MEMORANDUM

To: The Design Advisory Board
From: Mary O'Neil, Associate Planner
RE: 142-144 North Champlain Street; ZP 11-0808CA/MA
Date: May 10, 2011

Request: Construction of new 6 unit apartment building on vacant corner; site improvements.

Proposed Site Plan
SCALE: 1/8"=1'-0"

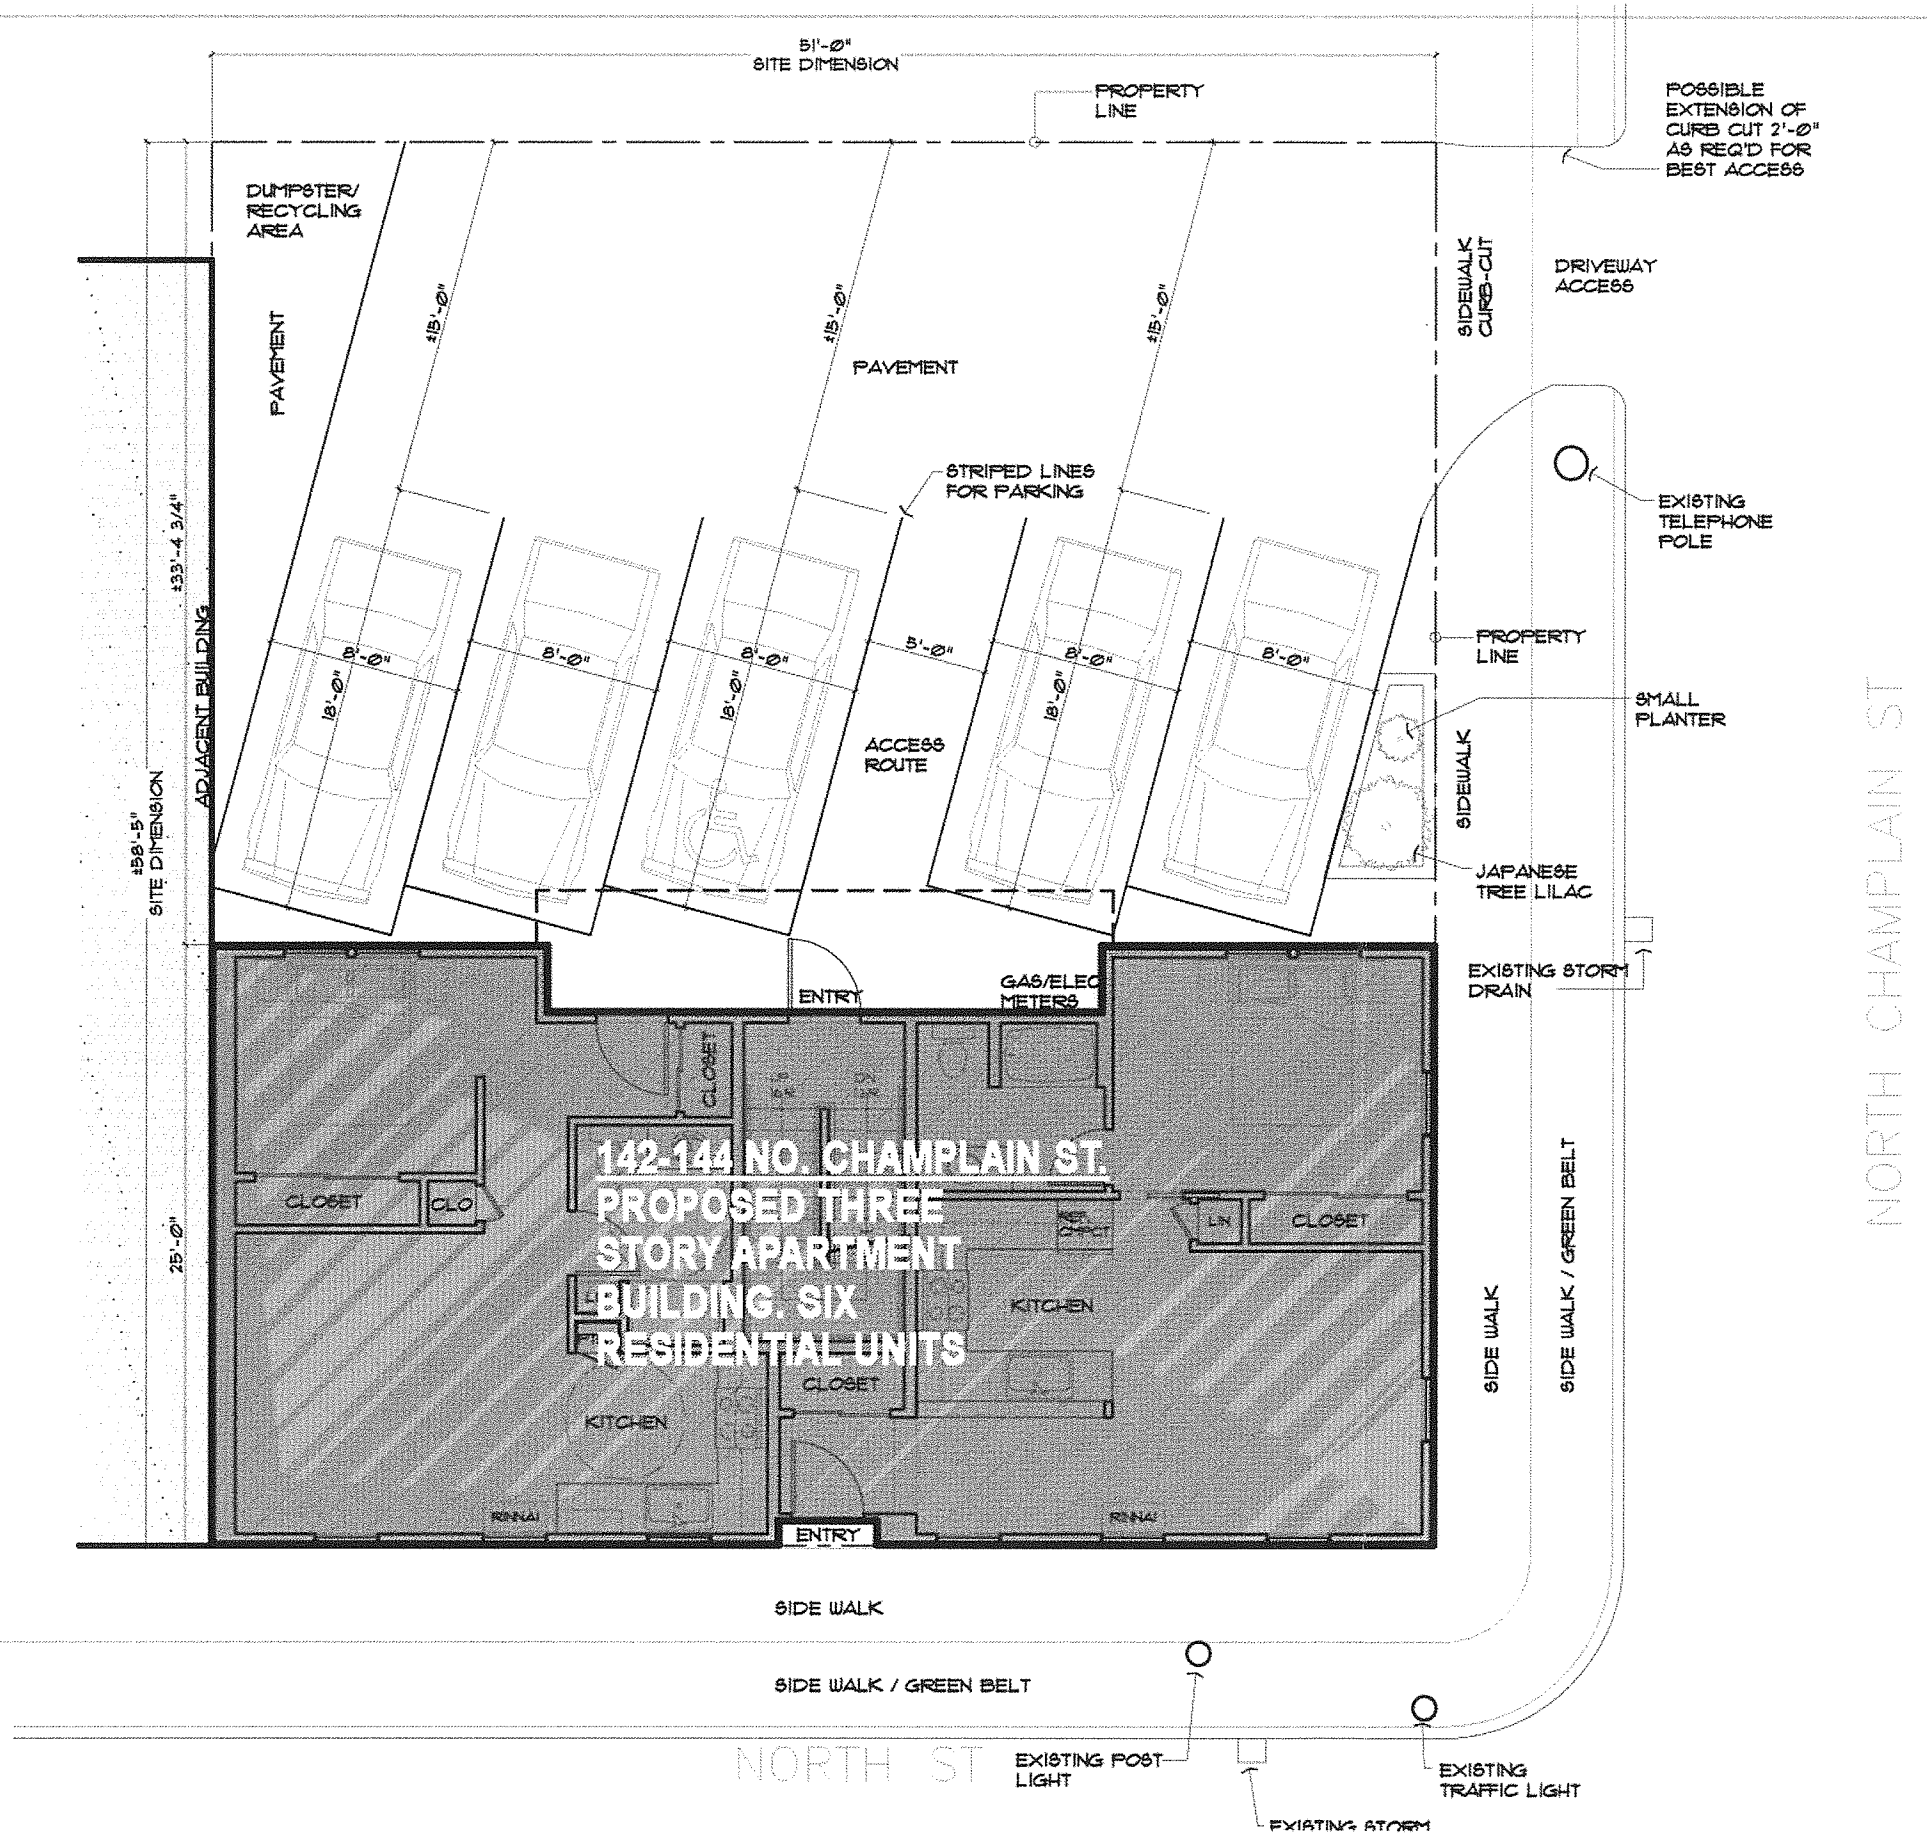
The plan provides for covered entrance porches on the south elevation for resident comfort and shelter from inclement weather. There is a limited area at the southeastern portion of the site for snow storage during winter months, if dumpster location does not prevent that consideration. This needs to be clarified.

The application proposes to replicate the previous parking arrangement, with 5 parking spaces directly off North Champlain Street. A small area for landscaping is proposed as a minor break between the public sidewalk and the parking area. This replicates a previous condition for the very constrained site.

This is an extremely constricted and contained site (2978 sf.) with a history of active commercial and residential use. Previous permitting recognized the inherent challenges of the site, and allowed for flexibility in access and parking due to the existing conditions. (See Zoning Permit 07-621CU.) Although the proposed parking plan does not meet the guidelines for vehicular back-up area as

prescribed in the Comprehensive Development Ordinance, the proposed parking plan replicates the previous non-conforming plan, and is allowable within the parameters of reclaiming existing non-conformities in a site lost to catastrophe. See **Sec. 5.3.8, Rebuilding after Catastrophe, (d)**.

The previous parking was non-compliant, with 5 parking spaces on site and **had been issued a 2 space parking waiver**. The parking plan proposed with redevelopment includes 5 on-site parking spaces, with a request for a **one space waiver**. There is no attempt to increase the degree of non-conformity.

1. Impact fees will be assessed, allowing credit for previous use and occupancy.
2. Two bicycle parking spaces shall be provided.
3. If the applicant proposes outdoor lighting fixtures, spec sheets need to be submitted to staff for review and approval.
4. The location of unit mailboxes needs to be defined.

5. This is a shared-use parking district, requiring 1 parking space per unit. Six residential units are proposed. Given the historic intensity of use at this corner, and the proposal for 6 new dwelling units (including one handicap accessible and one inclusionary unit), staff supports a **one-space parking waiver** as reasonable, subject to owner's agreement to **identify one unit without parking** per written lease arrangement. Previous permitting at this site implemented this strategy successfully. Review of the likely housing/occupancy characteristics of the property, proximity to downtown, and the immediate availability and frequency of bus transit, consideration may be made to satisfy a Parking Management Plan per Sec. 8.1.15.

Proposed South Elevation

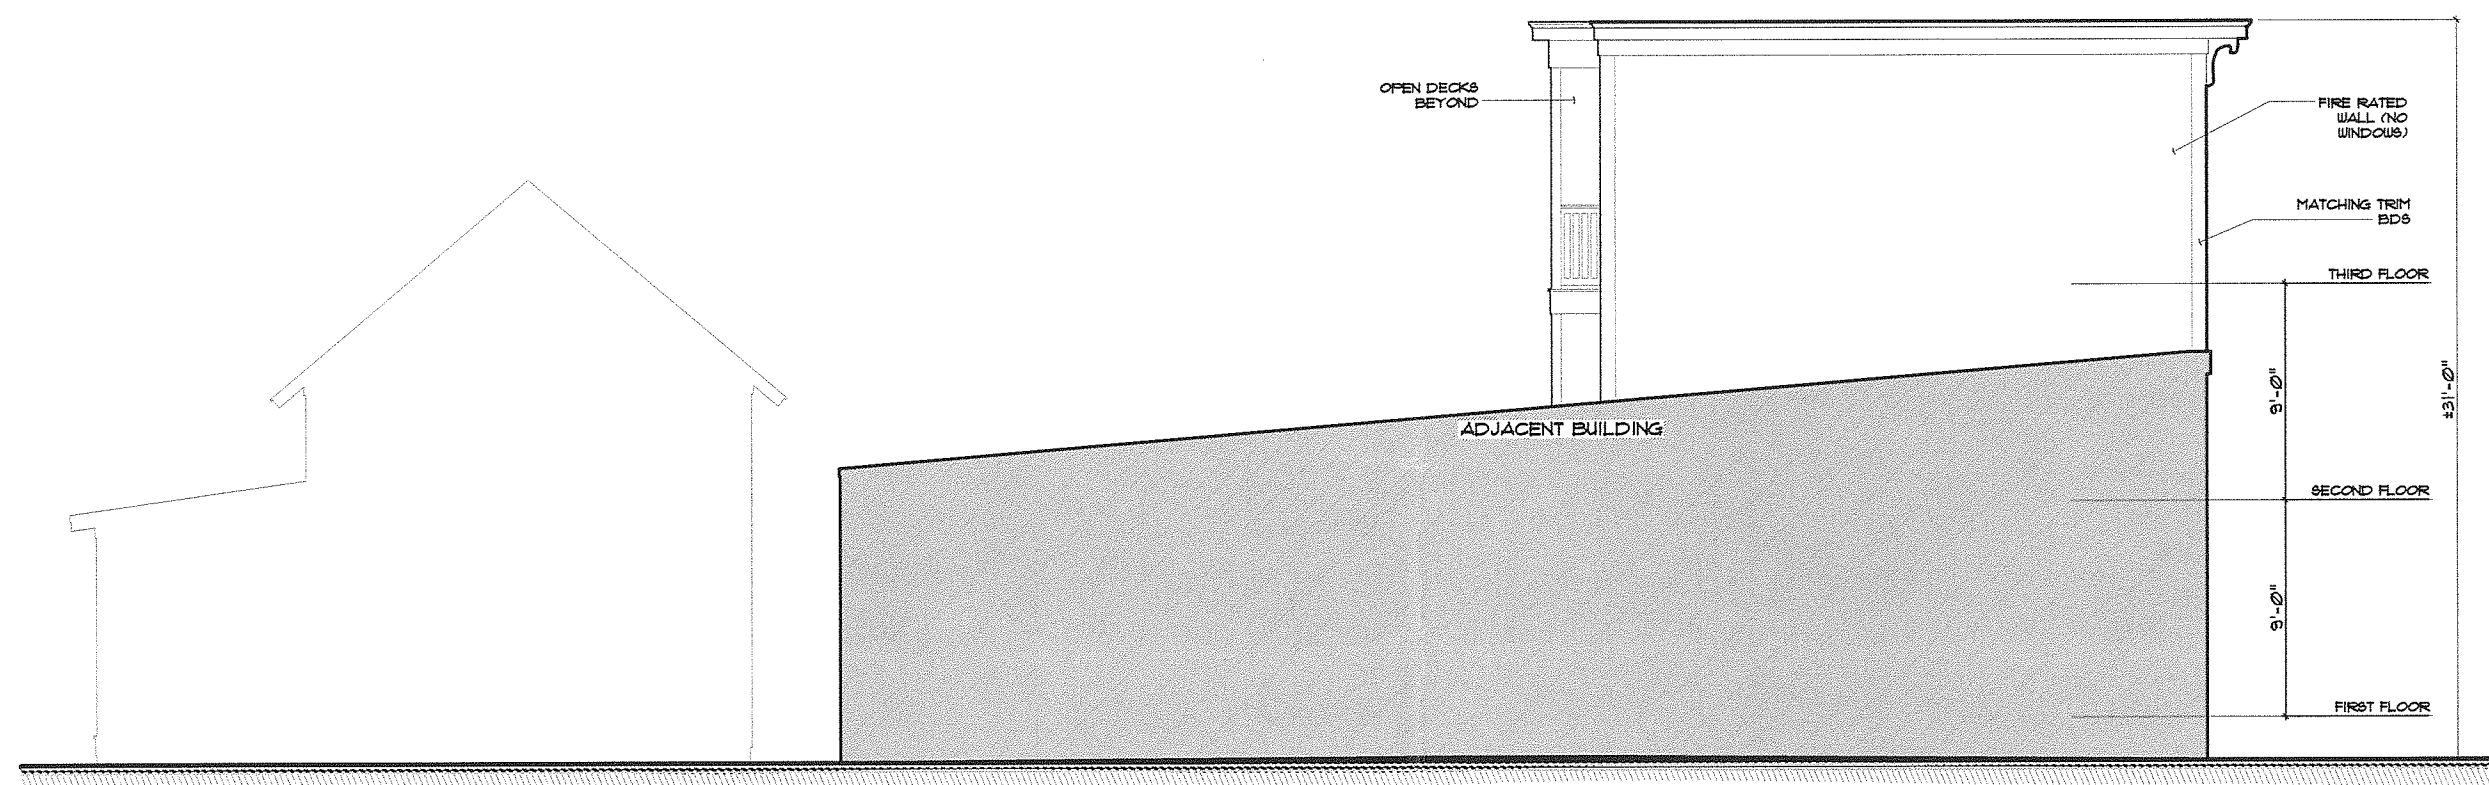
Elevations notes the location of heating vents on the north; electric and gas meters are proposed within the south porch entrance area. The location of mailboxes needs to be defined.

The submitted design has access to one unit centralled located on the North Street façade, yet it acts as a familiar and welcoming feature that blends nicely with the building and streetscape. Access to other units will be from the south façade, either through or under proposed open porches. The porch will provide a welcome measure of shelter from inclement weather conditions.
